SUBJECT: COMANCHE PEAK STEAM ELECTRIC STATION, UNITS 1 AND 2 - AMENDMENT
NOS. 49 AND 35 TO FACILITY OPERATING LICENSE NOS. NPF-87 AND NPF-89
(TAC NOS. M94167 AND M94204)

TEXAS UTILITIES ELECTRIC COMPANY
COMANCHE PEAK STEAM ELECTRIC STATION, UNIT 1
DOCKET NO. 50-445
AMENDMENT TO FACILITY OPERATING LICENSE

TEXAS UTILITIES ELECTRIC COMPANY
COMANCHE PEAK STEAM ELECTRIC STATION, UNIT 2
DOCKET NO. 50-446
AMENDMENT TO FACILITY OPERATING LICENSE

SAFETY EVALUATION BY THE OFFICE OF NUCLEAR REACTOR REGULATION

**FIGURE 2.1-1b
UNIT 2 REACTOR CORE SAFETY LIMITS**

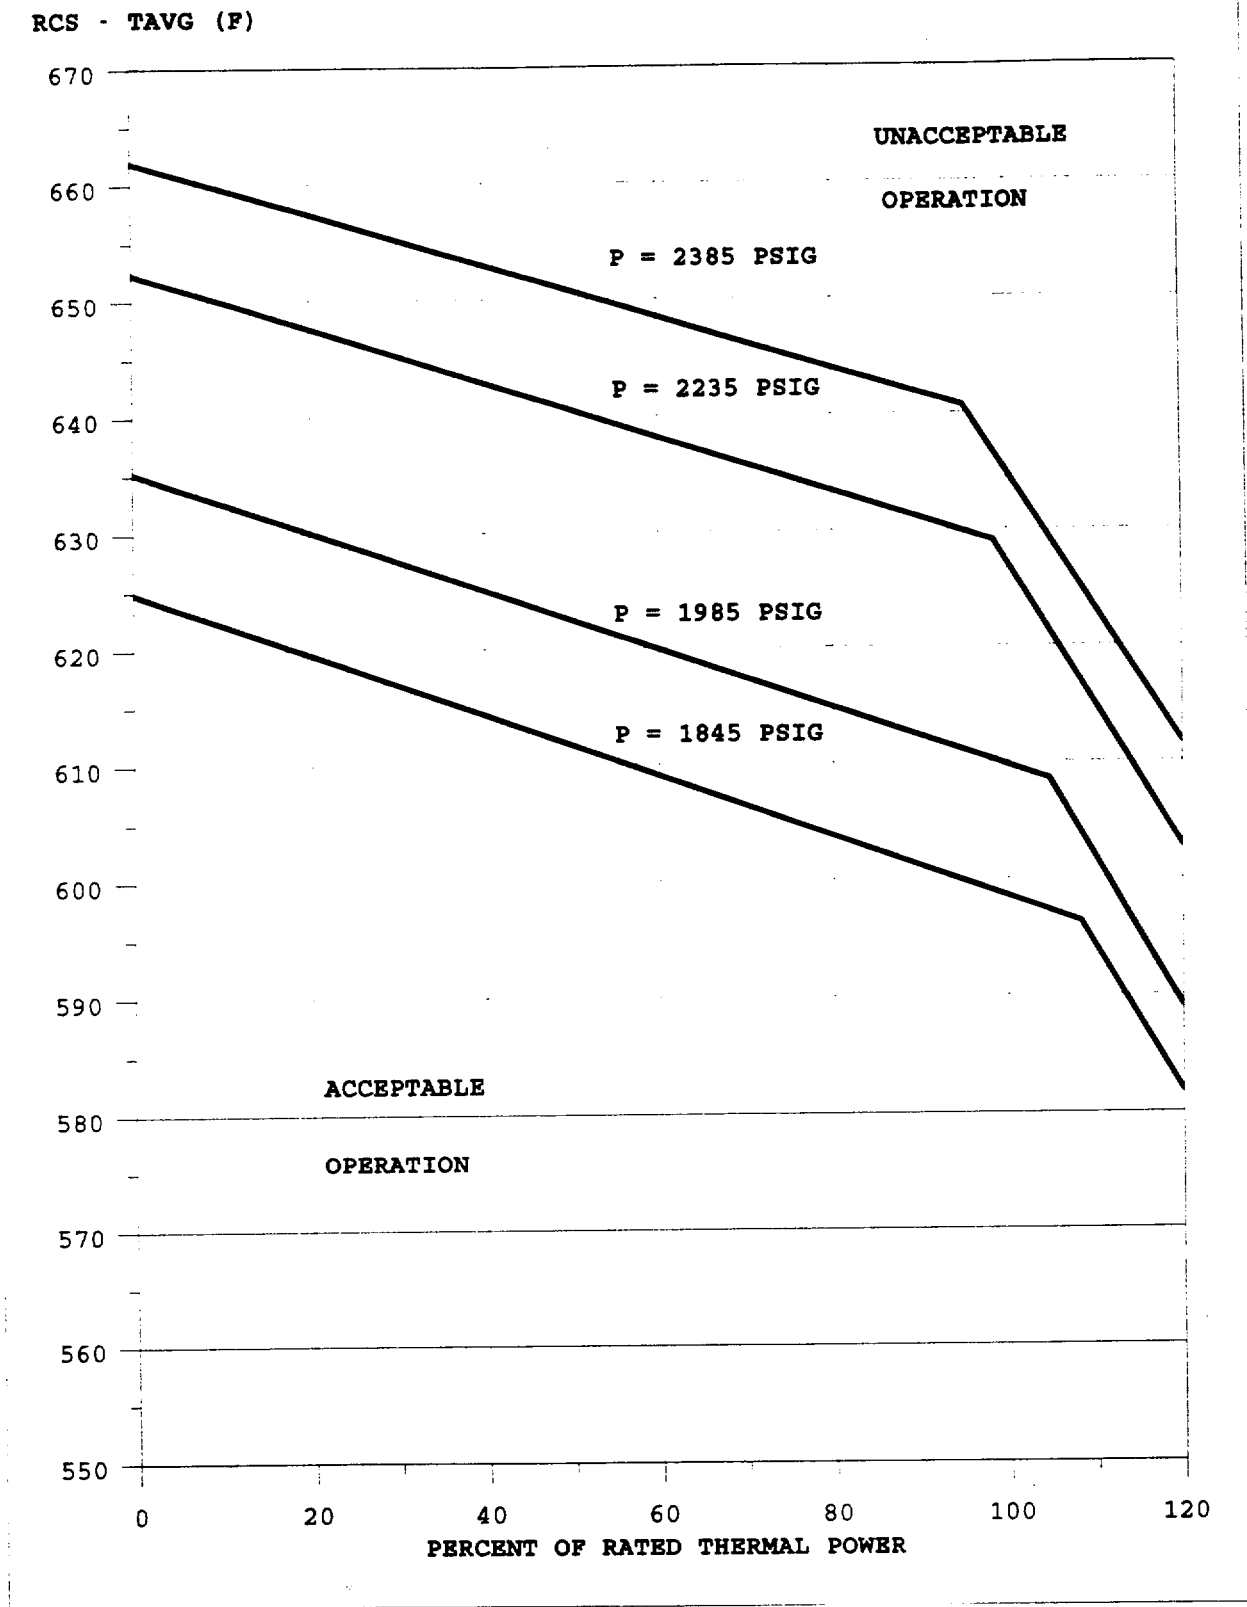
Using these methodologies and the changes in the RCS thermal design flow rate, calculations and analyses have been performed to identify the new core safety limit curves for Unit 2 (TS Figure 2.1-1b).

3.3 Revision to the Unit 2 Core Safety Limits

Beginning with Cycle 3, SPC will supply the nuclear fuel assemblies for Unit 2. During Cycle 3, the Siemens fuel assemblies will be co-resident with existing Westinghouse fuel assemblies.

TU Electric has used in-house reload analysis methodologies to determine the core safety limits and to meet applicable limits of the safety analyses for CPSES, Cycle 3. The in-house methodologies used by TU Electric to determine the core safety limits are wholly consistent with and represent no change to the TS 2.1 BASES for Safety Limits. TU Electric is using the NRC approved TUE-1 DNB correlation which has been approved by the NRC for the core configuration of Westinghouse standard fuel assemblies and Siemens fuel assemblies, including a mixture of these fuels which will be co-resident in the core of CPSES Unit 2 during Cycle 3. The calculation of the mixed core penalty used the approved code given in Reference 10. The effects of the mixed core on the large break LOCA analysis were evaluated in accordance with the approved methodology of Reference 10.

The core safety limits for CPSES Unit 2, Cycle 3 (TS Figure 2.1-1b) has been determined using the NRC approved TU Electric methodologies for determining core safety limits, an increase in the assumed RCS flow rate, and a safety analysis DNBR based on the NRC approved TUE-1 DNB correlation. The TUE-1 correlation DNBR limit plus margin constitutes the safety analysis DNBR limit.

The NRC staff has found the revisions to the Unit 2, Cycle 3 Core Safety Limits discussed above to be acceptable as they have been analyzed using NRC approved methodologies.
